# PERFORMANCE BULLETIN

## 6600 & 6700 Electronics Update

### - May Effect Valves Manufactured September 2000 to February 2002 -

Fig. 1

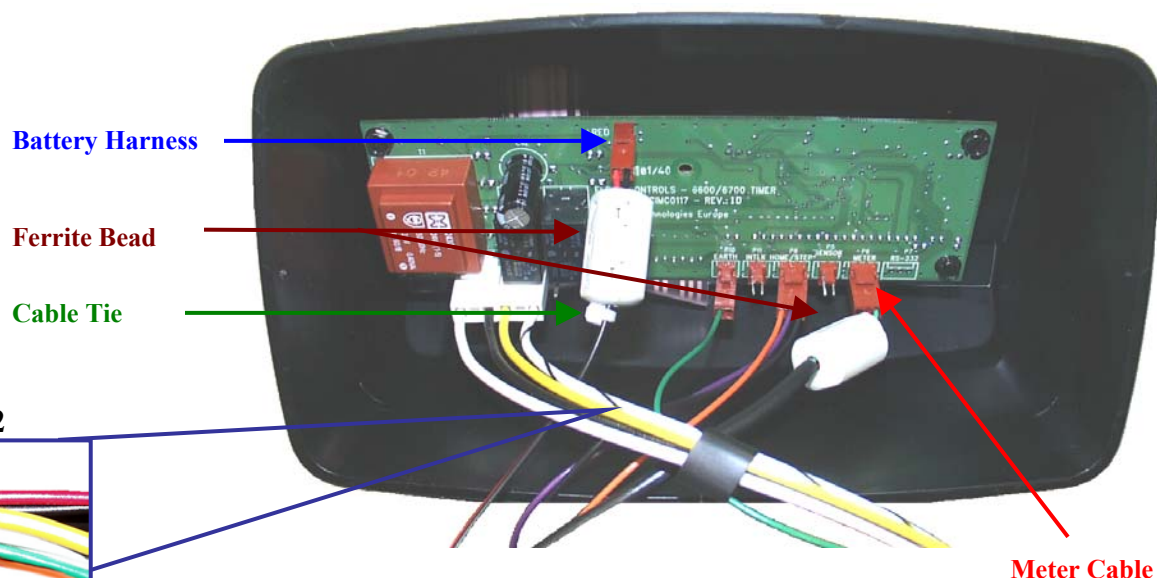
As of February 19, 2002 we are also installing ferrite beads onto the battery harness and the meter cable. These ferrite beads will eliminate electrical interference entering the control through the meter cable and battery harness, causing timer failure.

For field installations (see fig. 1) snap a **ferrite bead** (P/N 40508) around the **battery harness** close to the connector that plugs into the circuit board. Install a **cable tie** (P/N 14044) just below the **ferrite bead** to lock it into place. Snap another **ferrite bead** around the three individual **meter cable** wires close to the connector that plugs into the circuit board. A cable tie is not required for the ferrite bead on the meter cable. Finally, (see fig. 2) remove the cable tie that has all wires tied together and separate.
